Access Compliance Report

Public Rights-of-Way

Intersection ID: 48428	Main Street: ROUSAY_RD	Cross Street: DURNES DR	Location: NW
ADA ID: 51E26CA013B9	Ramp Type: PerpDiag	Initial Pass/Fail: Pass	Overall Compliance: No
Codes/Mitigation Info/Possible Solution		Field Measurements/Component Compliance

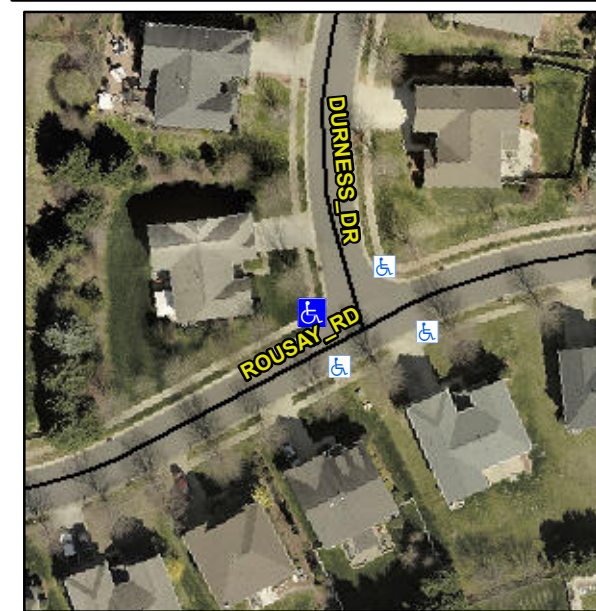
PROW/ADA:

R304.5.3, R305.2

Compliance	Description	Data	Compliance	Description	Data
N/A	Ramp Length (in)	47.0	Yes	Ramp Slope (%)	5.2
Yes	Ramp Width (in)	48.0	Yes	Ramp XSlope (%)	1.7
N/A	Flare Type LT	Sloped	N/A	Flare Type RT	N/A
N/A	Flare Slope LT (%)	6.9	N/A	Flare Slope RT (%)	2.2
N/A	Flare Traversable LT?	No	N/A	Flare Traversable RT?	No
Yes	Landing Length (in)	48.0	Yes	DWS Provided?	Yes
Yes	Landing Width (in)	48.0	Yes	DWS Contrast?	Yes
Yes	Landing Slope (%)	0.6	Yes	DWS Length (in)	24.0
No	Landing X Slope (%)	3.7	Yes	DWS Full Width?	Yes
N/A	Landing Curb? (Y/N)	No	No	DWS Offset (in)	3.0
N/A	Shared Landing?	No			
Yes	Gutter Ponding?	No	Yes	Gutter Slope (%)	2.9
Yes	Gutter Lip Ht (in)	0.0	Yes	Gutter X Slope (%)	1.8
N/A	Painted X Walk1?	No	N/A	Painted X Walk2?	No
	X Walk 1 Direction	To SE		X Walk 2 Direction	To NE
N/A	X Walk 1 Width (in)	N/A	N/A	X Walk 2 Width (in)	N/A
	X Walk 1 Slope (%)	2.2		X Walk 2 Slope (%)	2.3
	X Walk 1 X Slope (%)	3.2		X Walk 2 X Slope (%)	0.3

N/A	Ramp inside XWalk1?	N/A	N/A	Ramp inside XWalk2?	N/A
	Road Slope (%)	3.0	N/A	Clear Space?	Yes
	Road X Slope (%)	2.1	N/A	Clear Space to XWalk (in)	N/A
Yes	Any Obstructions?	No	Yes	Storm Grate/Utility Hazard?	No
	Obstruction Type			Storm Grate/Utility Type	
		N/A			N/A
			Yes	Surface Condition? (G/P)	Good

Remove & Replace Curb Ramp With Two New Directional Ramps or Equivalent.
